IMPROVEMENT PLANS FOR ROSEVILLE ROAD - ARCADE CREEK BRIDGE REPLACEMENT

(PN: T15068500)

AS BUILT

CCO #1
 PCO#3
 Field Instruction #3
 Attachment C
 Remove Existing Concrete Section
 July 16, 2015

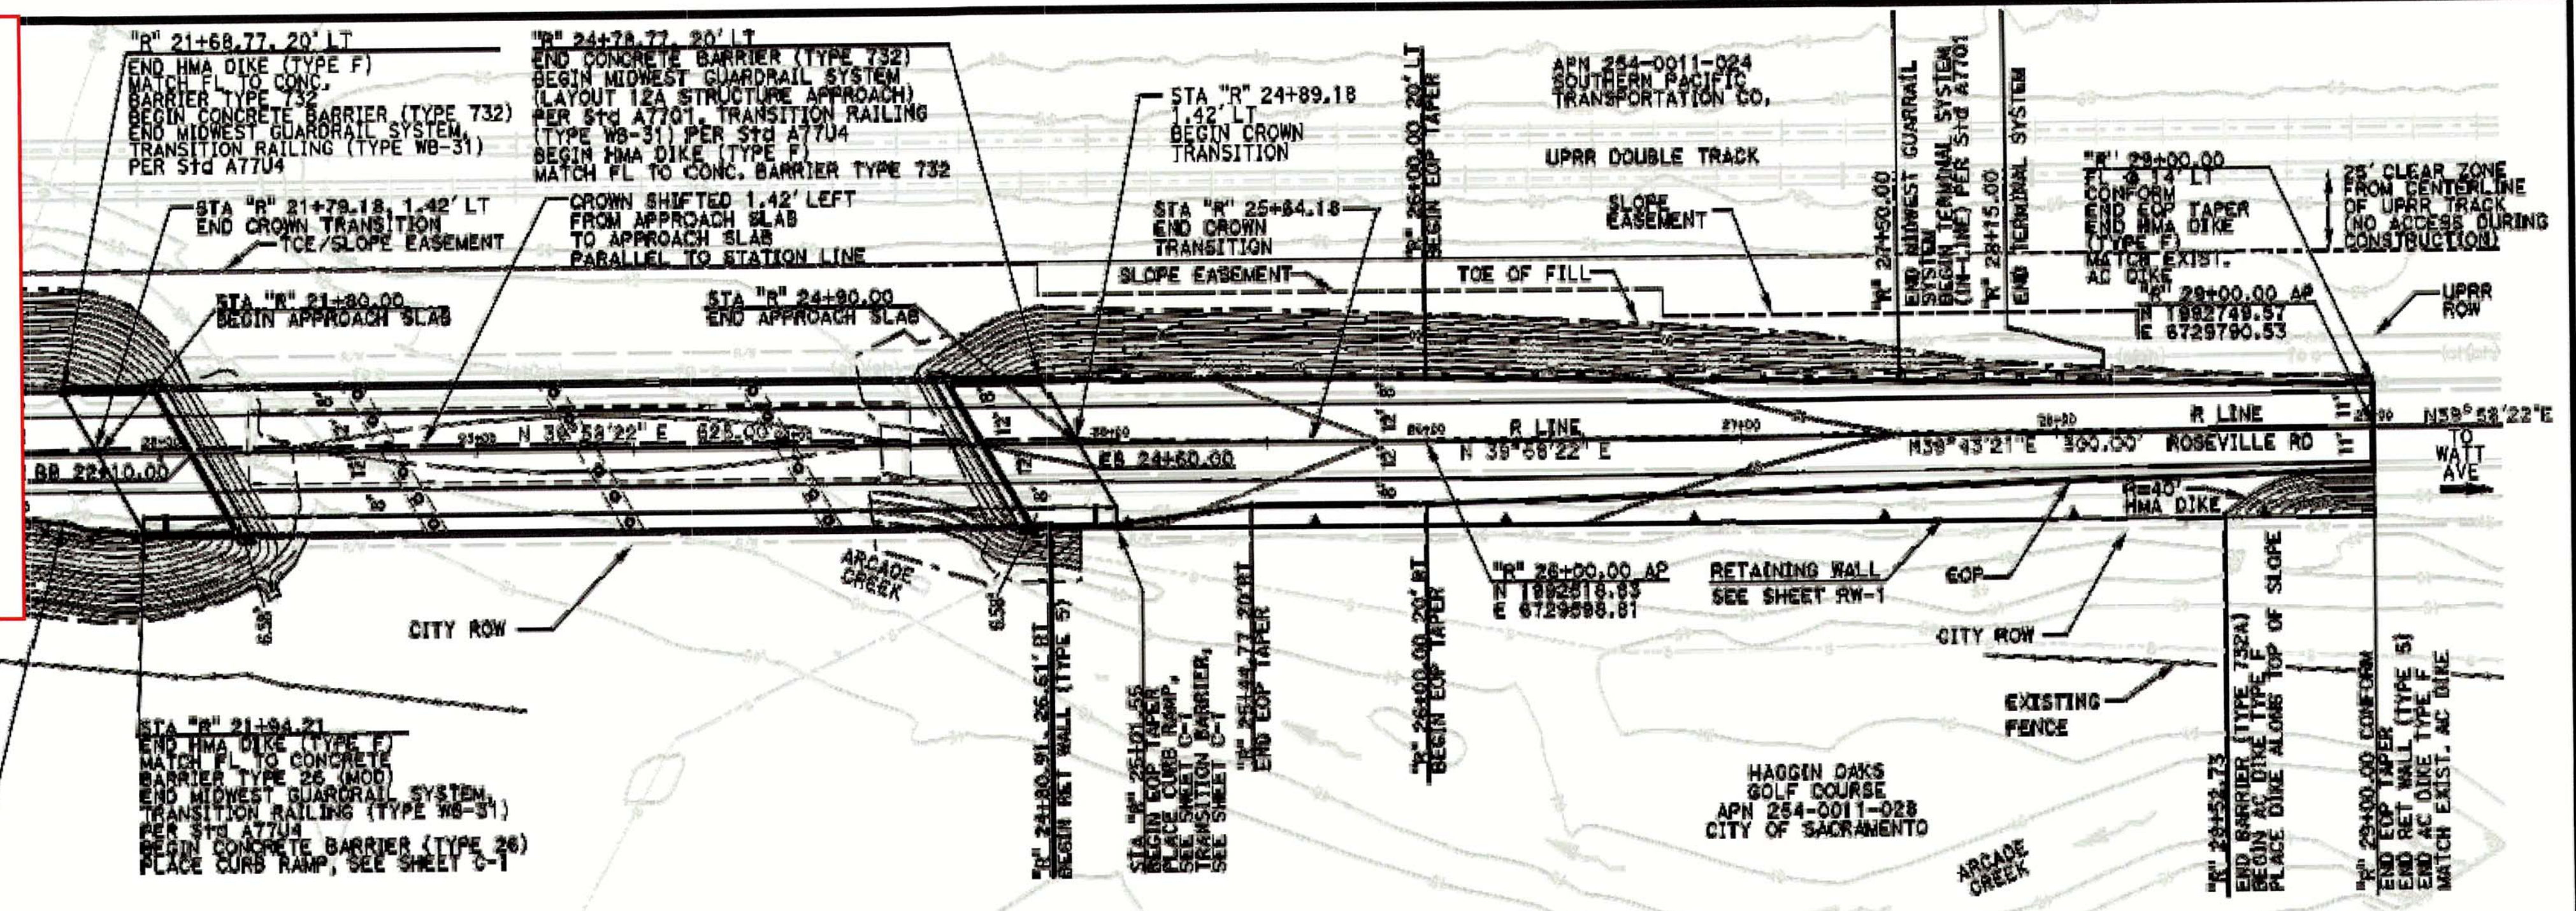
Remove Existing Concrete Section

IMPROVEMENT PLANS FOR
 ROSEVILLE ROAD - ARCADE CREEK BRIDGE REPLACEMENT
 PLAN AND PROFILE

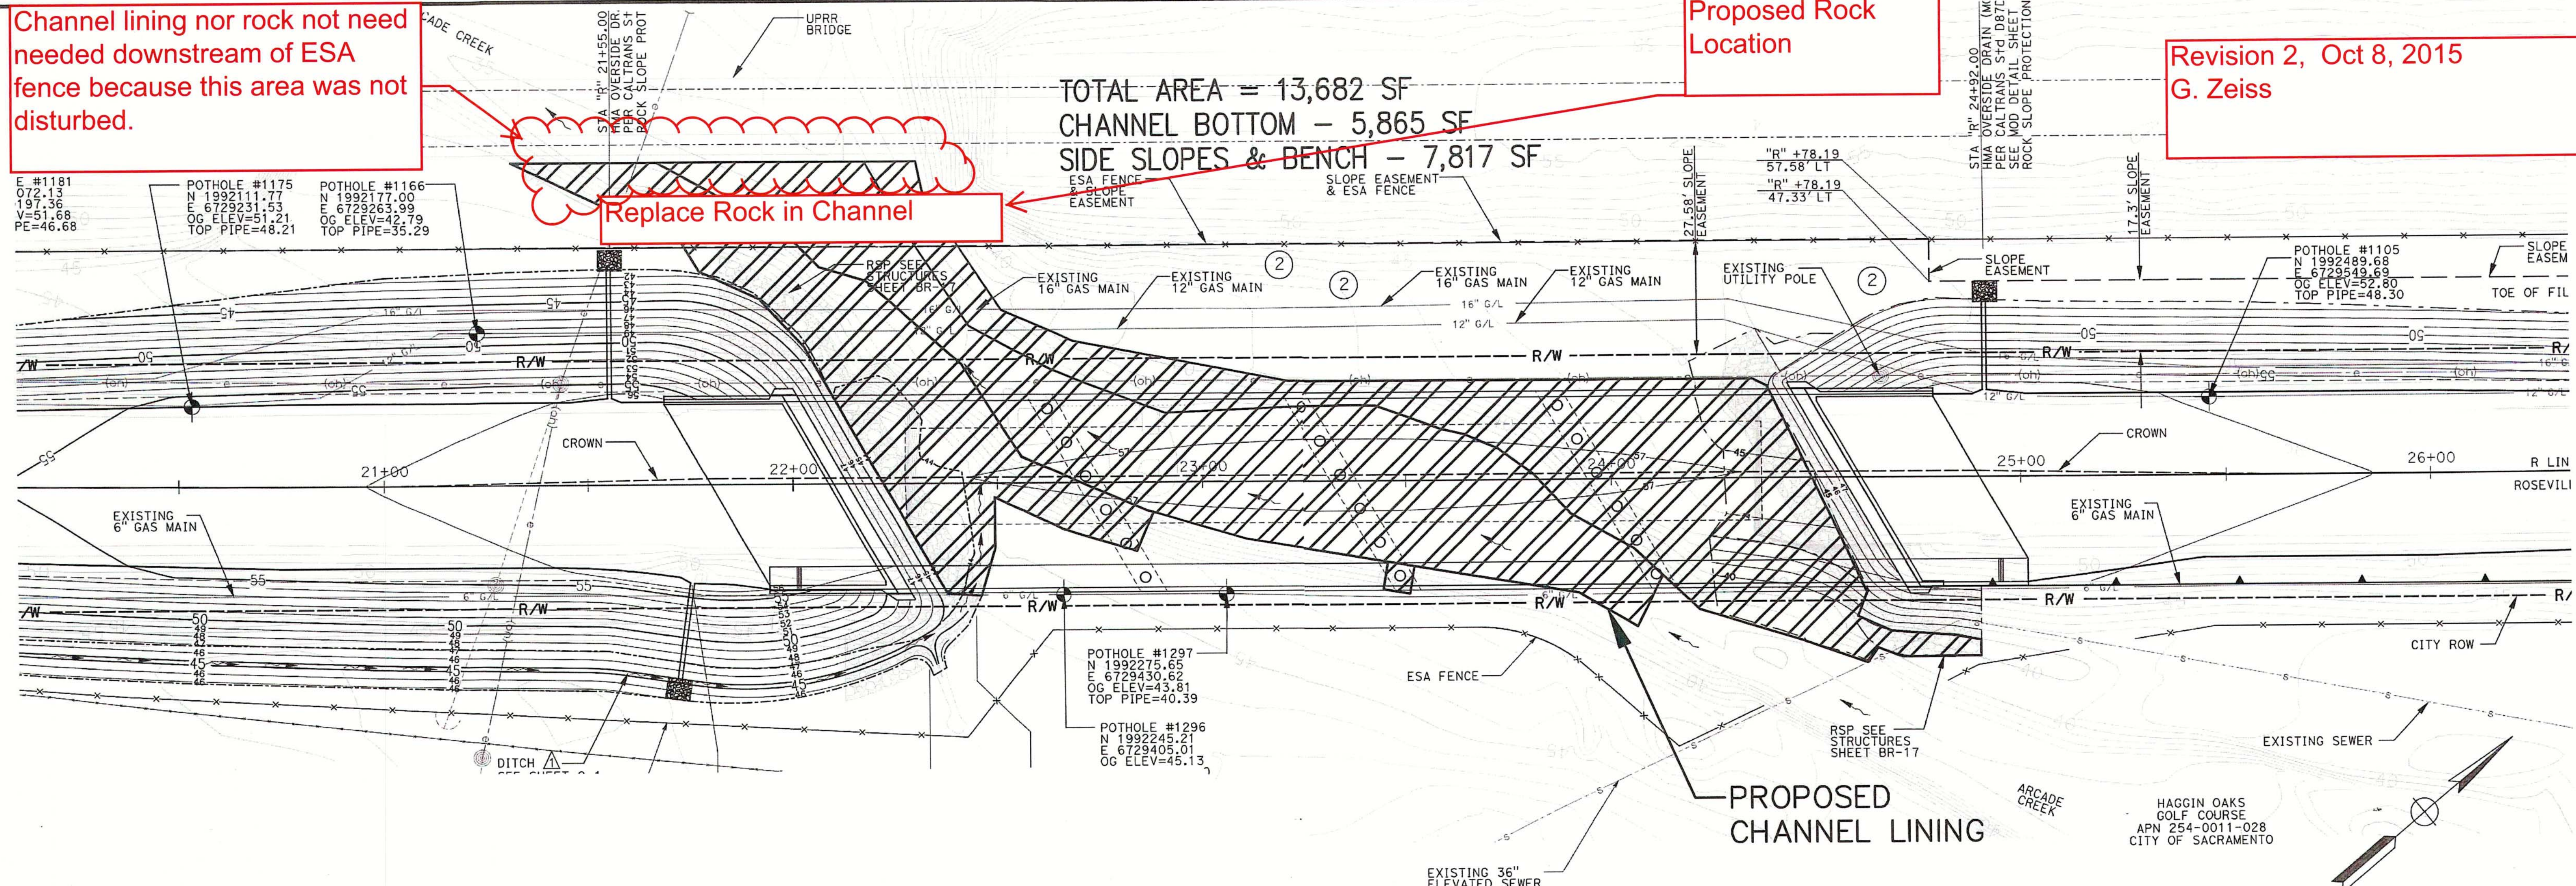
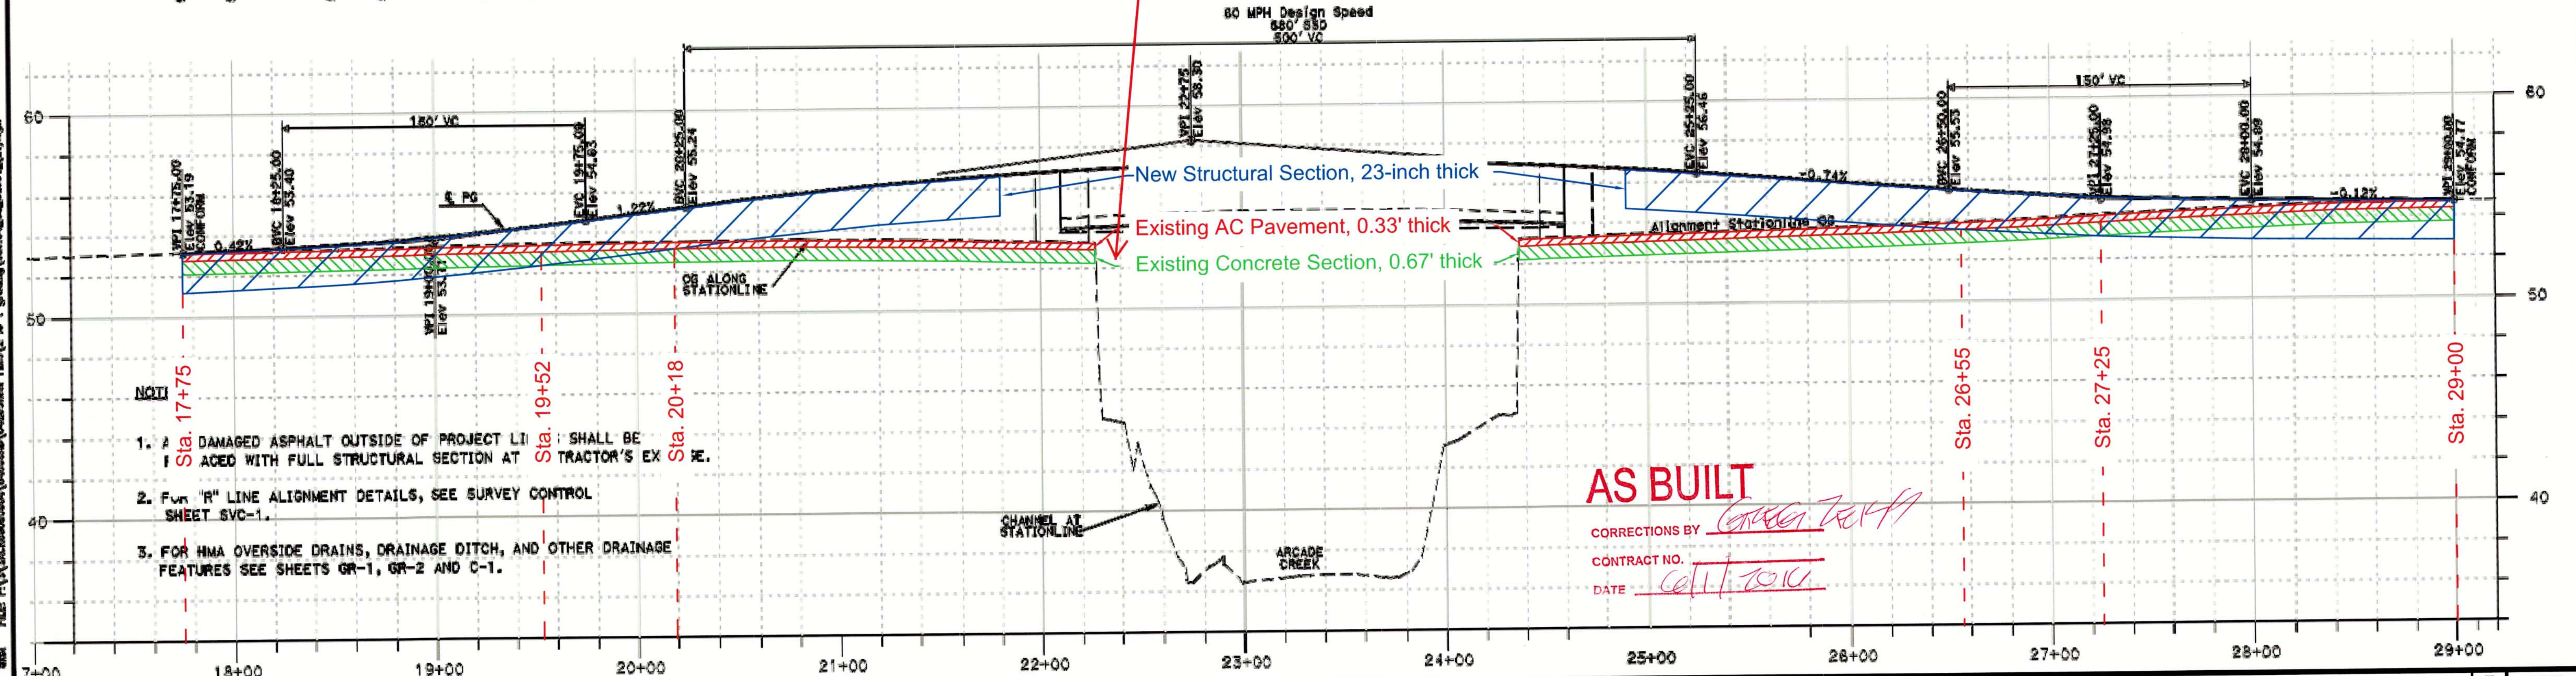
Channel lining nor rock not need needed downstream of ESA fence because this area was not disturbed.

Proposed Rock Location

Revision 2, Oct 8, 2015
G. Zeiss

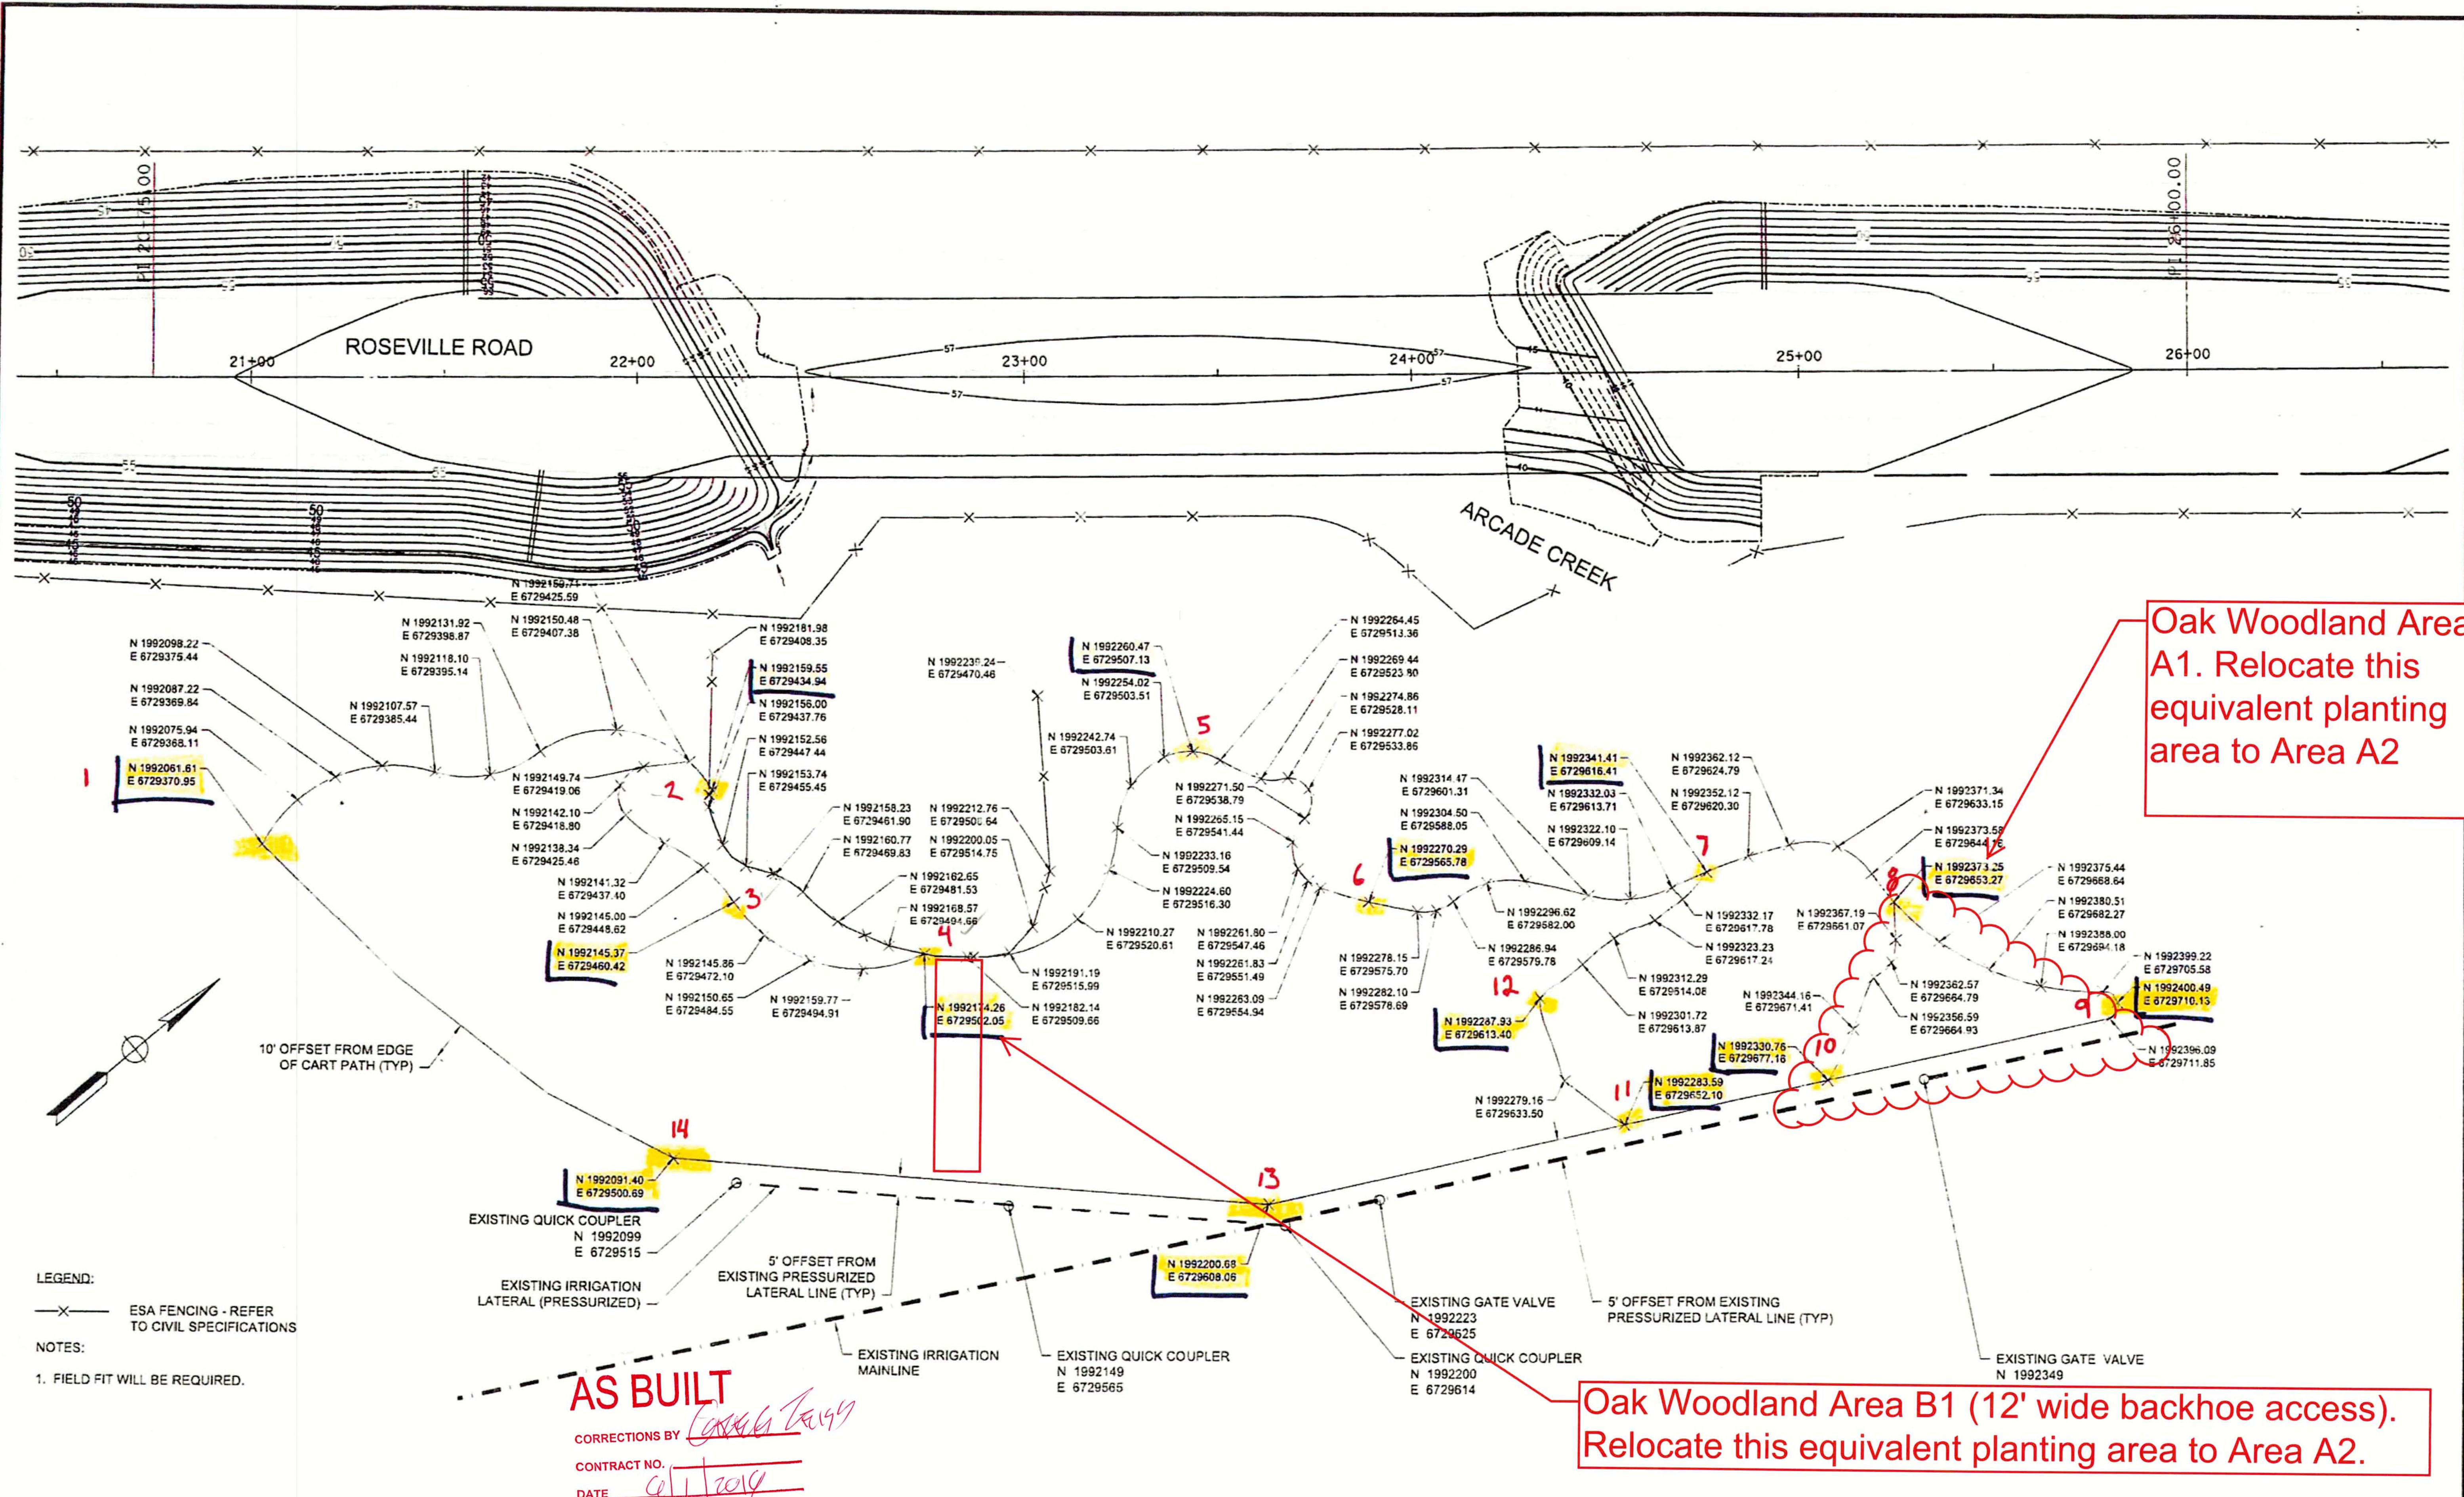
Oak Woodland Area A1. Relocate this equivalent planting area to Area A2

Oak Woodland Area B1 (12' wide backhoe access). Relocate this equivalent planting area to Area A2.
